VILLAGE OF CALEDONIA UTILITY DISTRICT MEETING AGENDA

RE: Storm Water Management Plan & Site Construction Plan –
Conditional Approval – Olympia Brown School Addition

RE: Racine Unified School District – Olympia Brown School Addition – Storm Water Management Plan & Site Construction Plan Review

The Caledonia Utility District and the Caledonia Engineering Department has performed a review of the Storm Water Management Plan & Site Construction Plans submitted February 15, 2024 for the Racine Unified School District – Olympia Brown School Addition at 2115 5 ½ Mile Road in the Village of Caledonia. Below is a summary of the review comments.

General Comments

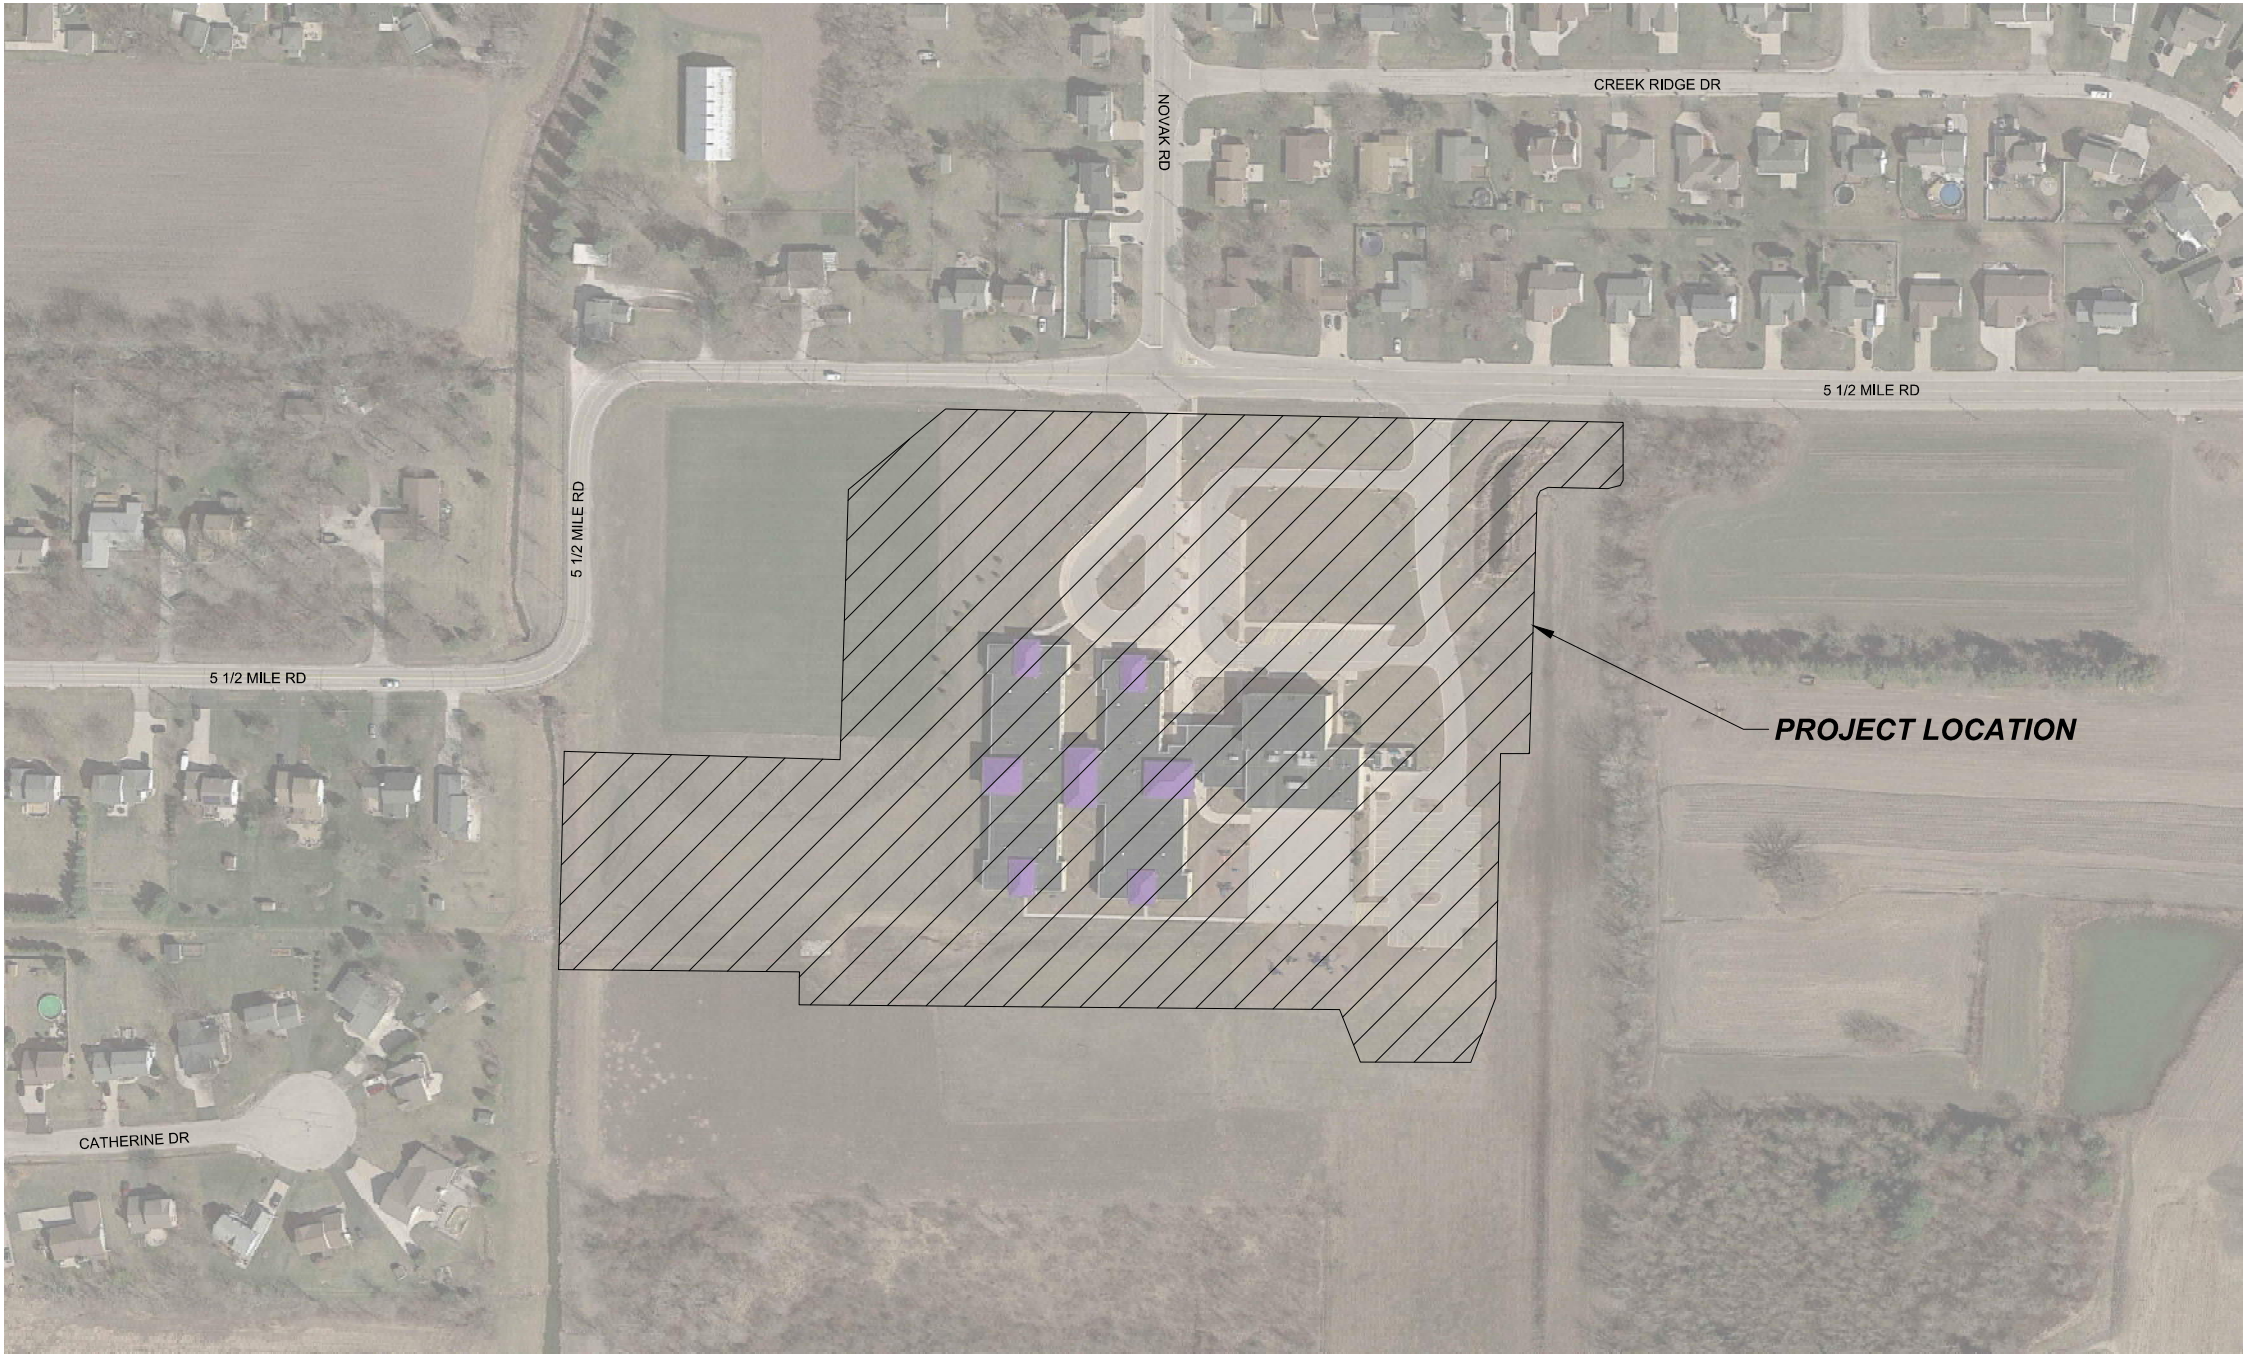
- Recommend relocating Sheets C1.30, 1.40 and 1.50 to the beginning of the Plan set before the proposed site work.
- Provide NOI permit to the Village and apply for the Local Land Disturbance Permit.
- Complete all other local permits in conjunction with state requirements.
- Will need to update the 2015 TIA with new traffic generated from the Addition to the School. Review that the existing improvements (which were installed with the original school) are still satisfactory for meeting the minimum LOS. Ultimately this should be an addendum to the old TIA.
- When the Site Construction Plans are approved by the Caledonia Utility District & Village Engineering Department, there shall be 3 Professional Engineer stamped hard copies and 1 stamped electronic (pdf) copy submitted for the development.

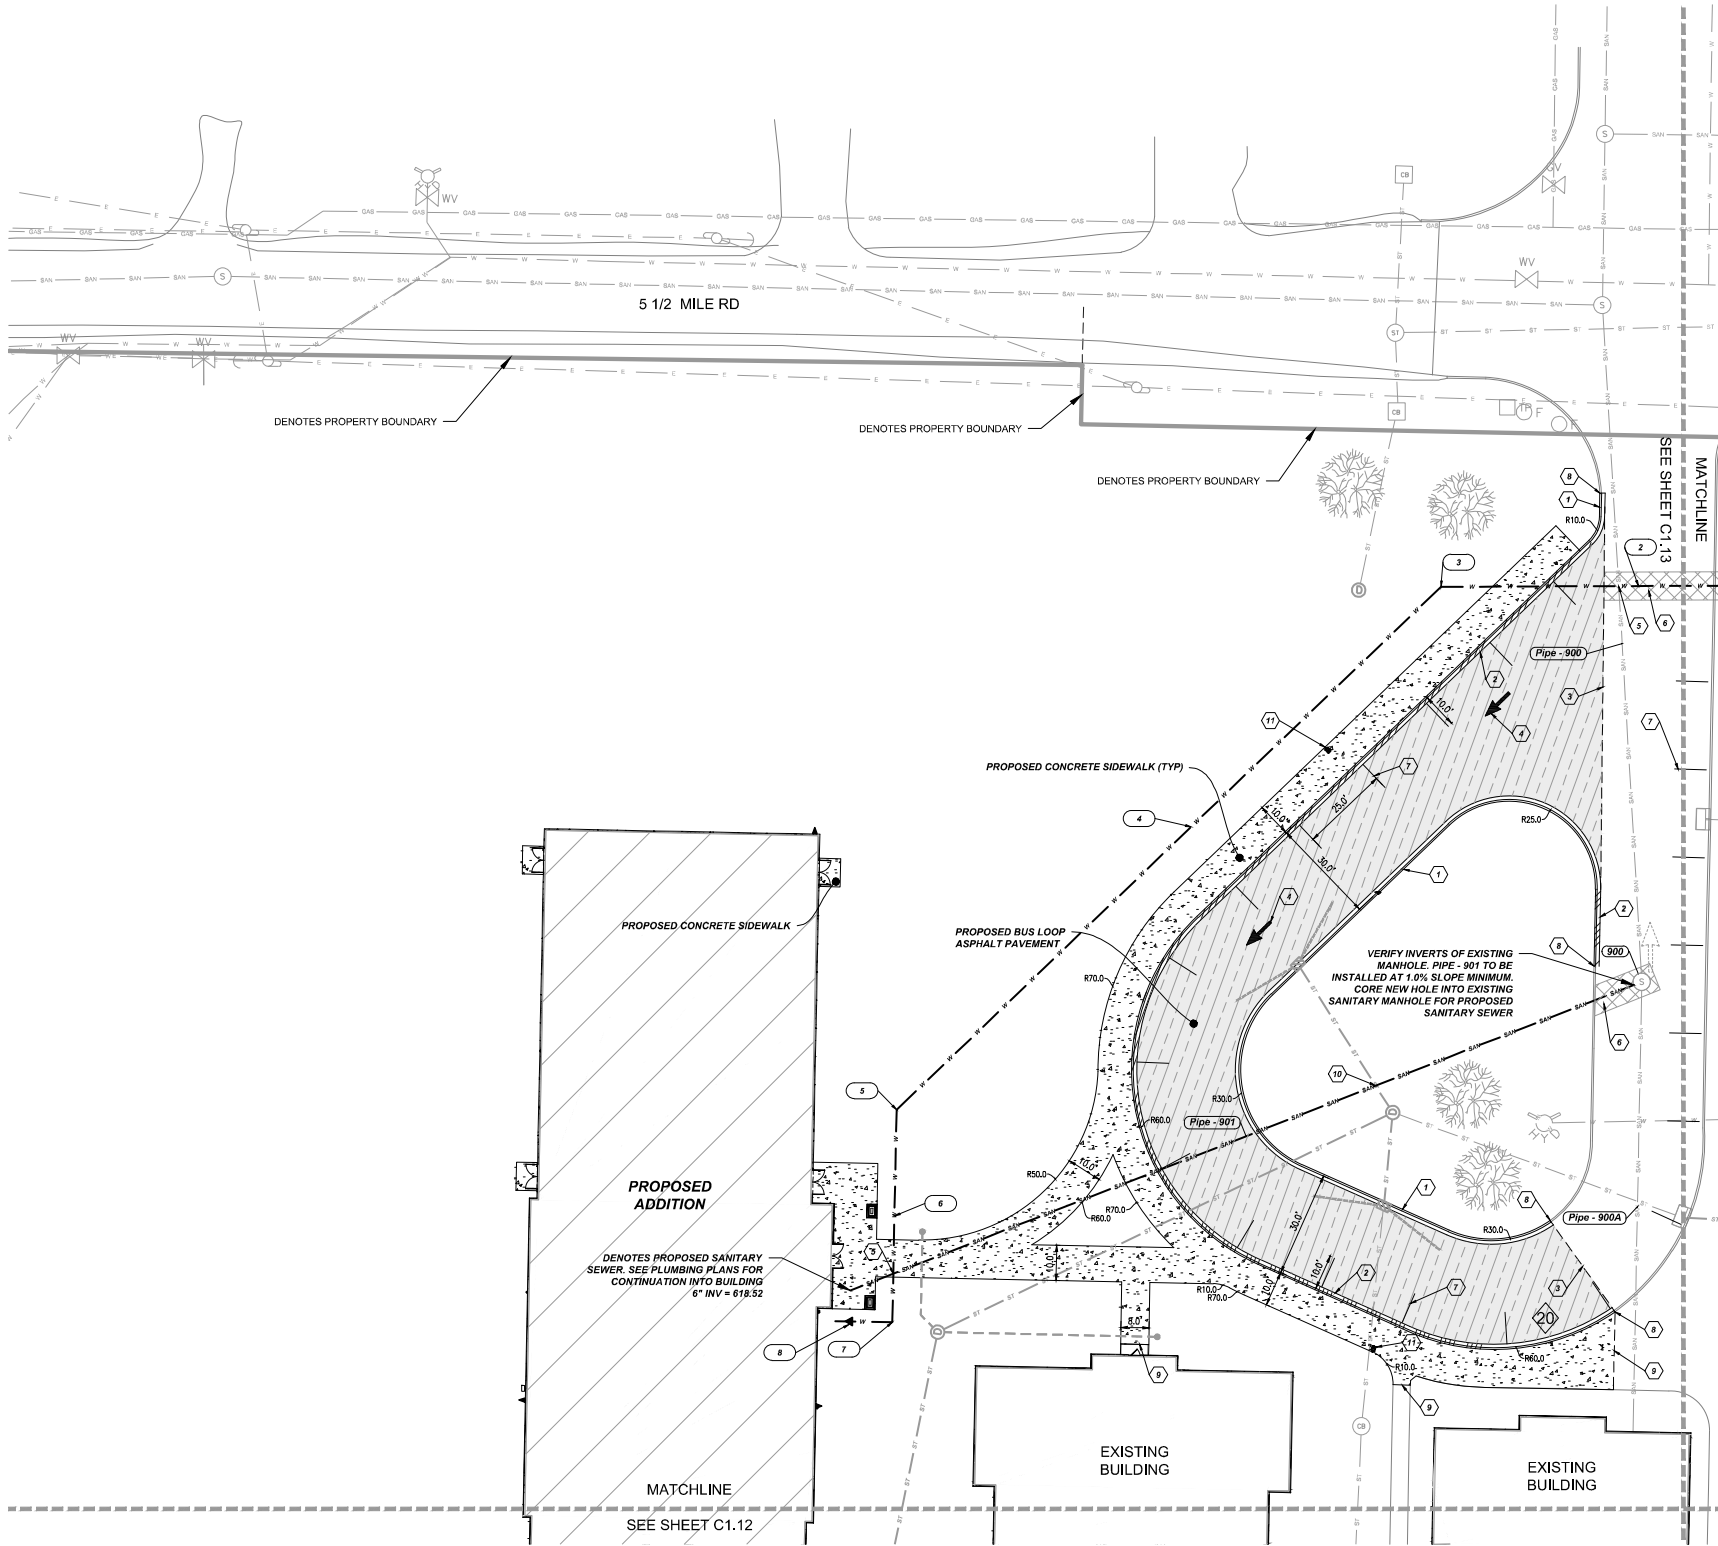
All Utilities (Sanitary Sewer, Watermain & Storm Sewer) will need to be installed to Caledonia Utility District Standards.

Add notes that sanitary sewer lateral will be mortared both inside and outside of the manhole. Also recommend that a bench is poured in the manhole if not already.

GRADING PLAN - SOUTH EAST

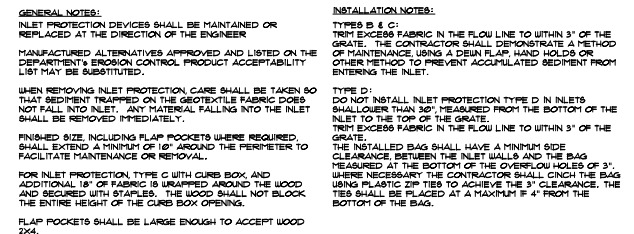
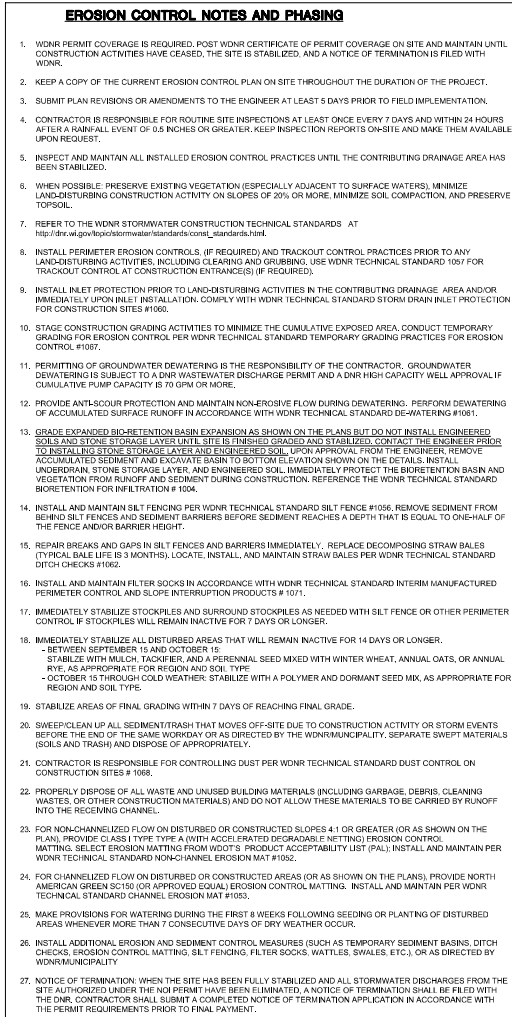
- Pipe 200E to 200D has a bend in the pipe without a structure. Will need to add a structure or eliminate the bend from the pipe run.

- Pipe 200C to 200B has a bend in the pipe without a structure. Will need to add a structure or eliminate the bend from the pipe run.
- Pipe 200B to 200A has a bend in the pipe without a structure. Will need to add a structure or eliminate the bend from the pipe run.
- Pipe 402B to 402A has a bend in the pipe without a structure. Will need to add a structure or eliminate the bend from the pipe run.
- Pull out contours off of the additional parking lot to create a lessor slope off of the parking lot area. Recommend a 10:1 slope.
- Not required but suggested that the new parking lot expansion to the South include inlets extended from CB203 and CB204. Could create a low point in the southern lot and reduce the overall height you have to raise this parking lot - also reducing the fill and grading work.
- Will need to call out a pipe material for pipe run 402. Recommend PVC.
